Department initiated Amendment

| Licence Number | L8846/2014/2 |
| Licence Holder | Phosphate Resources Ltd |
| Premises | Christmas Island Phosphates Christmas Island INDIAN OCEAN TERRITORIES WA 6798 Legal description – Being Lot 47 and 48 on Plan 218106, Lot 51 on Plan 218108, Lot 53 on Plan 218110, Lot 197 on Plan 218134, Lot 482 and 488 on Plan 219653, Lot 554 on Plan 221294, Lot 622 on Plan 43303, Lot 637 on Plan 43304, Lot 3001 and 3002 on Plan 41813, and Lot 3022 on Plan 43297, as depicted in Figure 1, Schedule 1 and as defined by the coordinates in Schedule 2 |

Figure 4: Indicative locations of monitoring equipment from AQMP Version 001

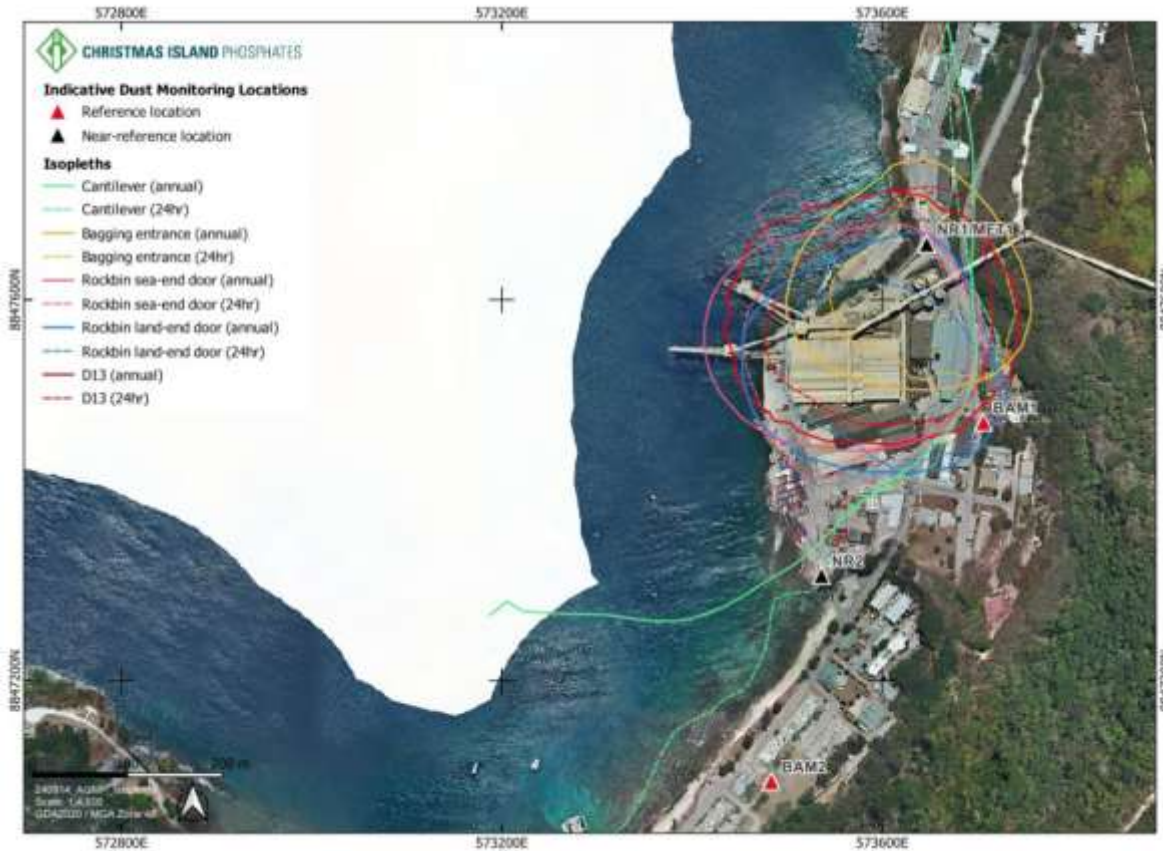
The department reviewed the AQMP submitted by PRL and found that the proposed monitoring equipment was generally consistent with previous recommendations. However, the AQMP did not address the department's recommendation to include a spare monitor to ensure continuity during offsite servicing, calibration, or repair. The Licence Holder has since advised that a portable dust monitor will be available to serve as a spare unit.

The proposed locations for BAM1, NR1, and NR2 were considered appropriate, as they are representative of ambient air quality near sensitive receptors. In contrast, the location initially proposed for BAM2 was assessed as unsuitable. This was due to the presence of residential and other sensitive receptors between the emission sources and the monitor, and the potential for interference from a nearby three-storey building, which could affect the accuracy of air quality monitoring results.

Consequently, the department requested that the Licence Holder propose an alternative location for BAM2. In response, PRL identified a new location adjacent to the Malay Club. This revised location was subsequently incorporated into Version 002 of the AQMP, which was submitted to the department on 2 July 2025 and includes the updated BAM2 location, as shown in Figure 5.

Figure 5: Indicative locations of monitoring equipment from AQMP Version 002

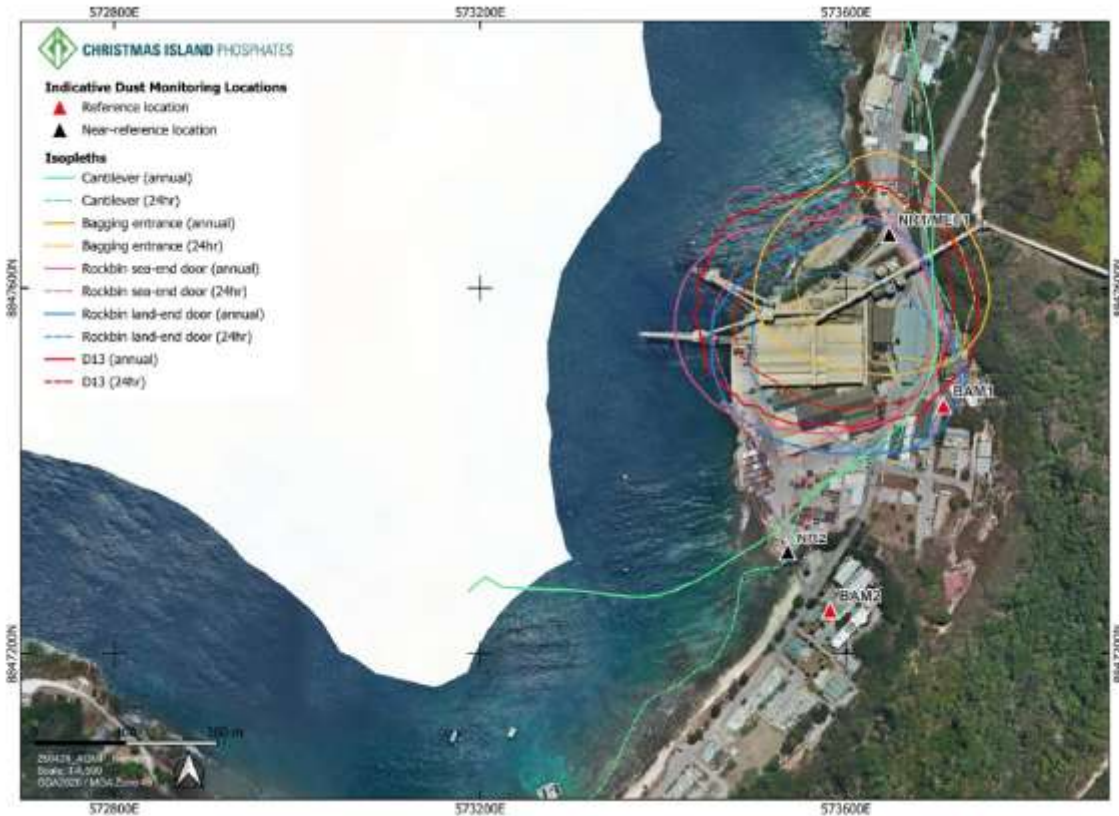
Following assessment, the department determined that the revised BAM2 location was appropriate. The new site is suitably positioned to detect potential impacts at sensitive receptors north of Kampong and is free from immediate obstructions that could interfere with monitoring results.

Legal access to the land required for installation of BAM2 is still in progress. Therefore, a condition has been specified in the licence amendment requiring the Licence Holder to obtain legal access to the land on which monitoring equipment will be located prior to installation.
